NINTH AMENDMENT TO SUBDIVISION AGREEMENT

(Southport East Subdivision)

RE: 2007 Minor & Administrative Plat Reviews
Southport East Replat Nine
Review of Initial Submittal
TD² File No. 171-344

RE: Proposed PUD Plan
Lots 1-4, Southport East Replat Nine
Initial Review
TD² File No. 171-345

EXHIBIT "E"
COMMON AREA IMPROVEMENTS
SOUTHPORT EAST REPLAT NINE
 SARPY COUNTY, NEBRASKA

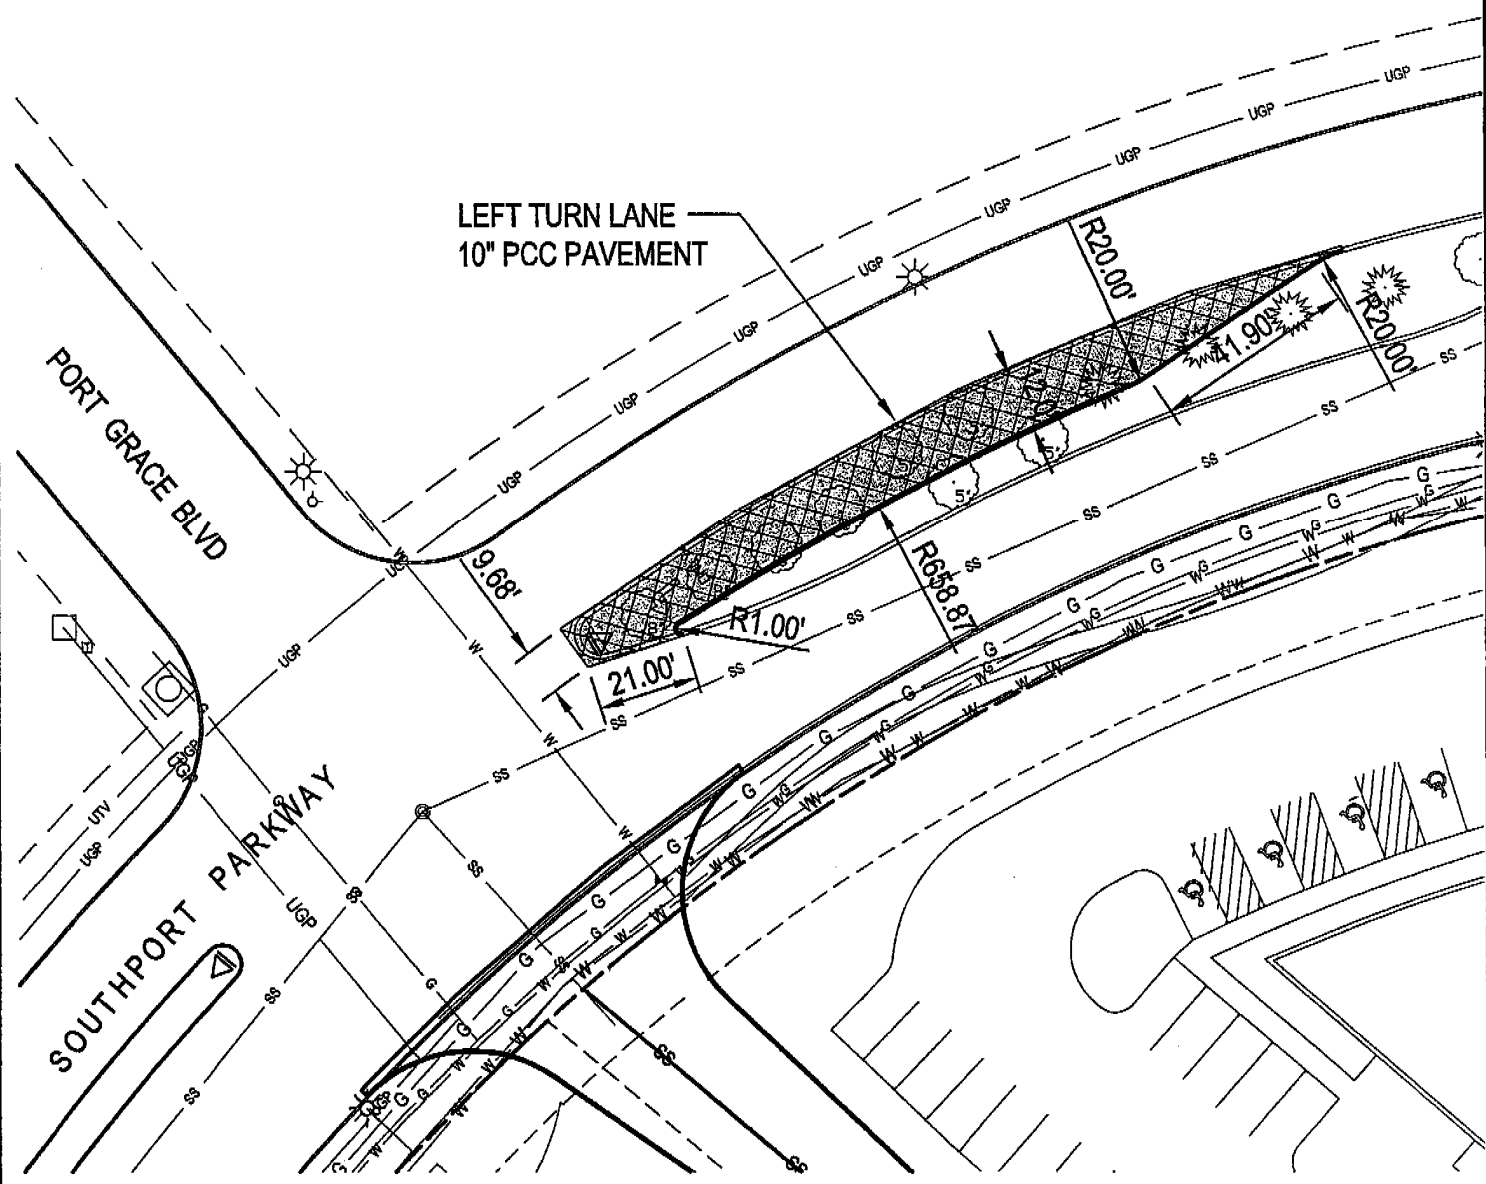
- 12. Common Improvements/Maintenance. For purposes hereof, the following provisions shall be applicable:
 - a. Common Area Improvement Defined. The term Common Area Improvement shall mean all infrastructure and improvements set forth on Exhibit "E". Said Common Area Improvements shall include, but not be limited to, ingress and egress, roads, parking, storm drainage, sanitary sewer, public utility infrastructure or services and other infrastructure needs for or benefiting more than a single lot. The Common Area Improvements are internal to the replat area and are shown on the attached Exhibit "E" incorporated herein by this reference.

EXHIBIT "F"
IMPROVEMENTS TO SOUTHPORT PARKWAY
SOUTHPORT EAST REPLAT NINE
 SARPY COUNTY, NEBRASKA

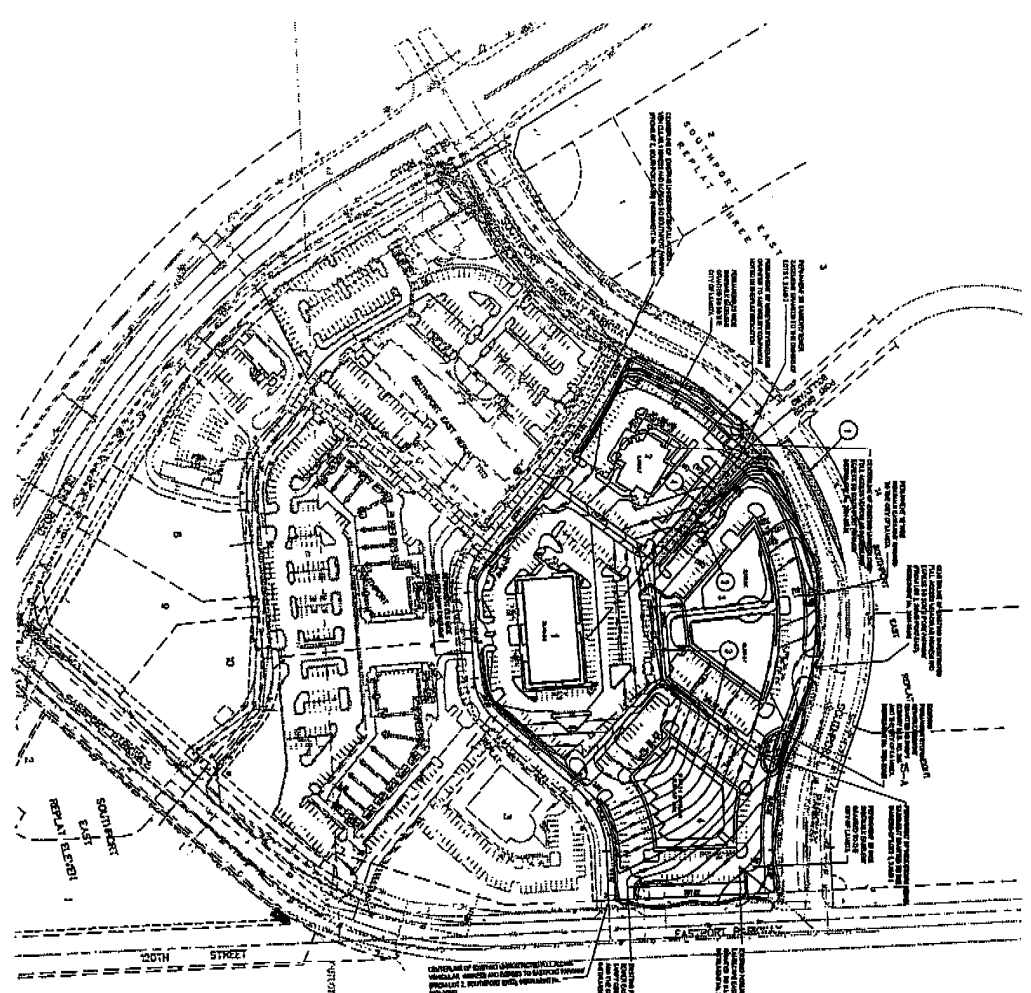
- 11. Improvements to Southport Parkway. Improvements to Southport Parkway, a public street, to construct a left-turn bay on Southport Parkway will benefit Replat Nine. A drawing of these improvements is attached hereto as Exhibit F. The costs of the improvements to construct the left-turn bay on Southport Parkway shall be paid by the Subdivider. Upon City's acceptance of the improvements, City will assume maintenance responsibility.

5. There will need to be a modification to the existing island in Southport Parkway to create a left-turn bay for westbound traffic to turn left into the proposed access opposite of Port Grace Boulevard. This modification will need to be done at private expense and will require detailed plans and specifications. Performance bonds and insurance certificates will be required since this will be a public street improvement. The amendment to subdivision agreement for this plat will need to address this item.

5. There shall be a modification to the existing island in Southport Parkway to create a left-turn bay for westbound traffic to turn left into the proposed access opposite of Port Grace Boulevard. This modification will need to be done at private expense and will require detailed plans and specifications. It shall be submitted to City for approval. Submission to City of performance bonds and insurance certificates will be required since this is a public street improvement.
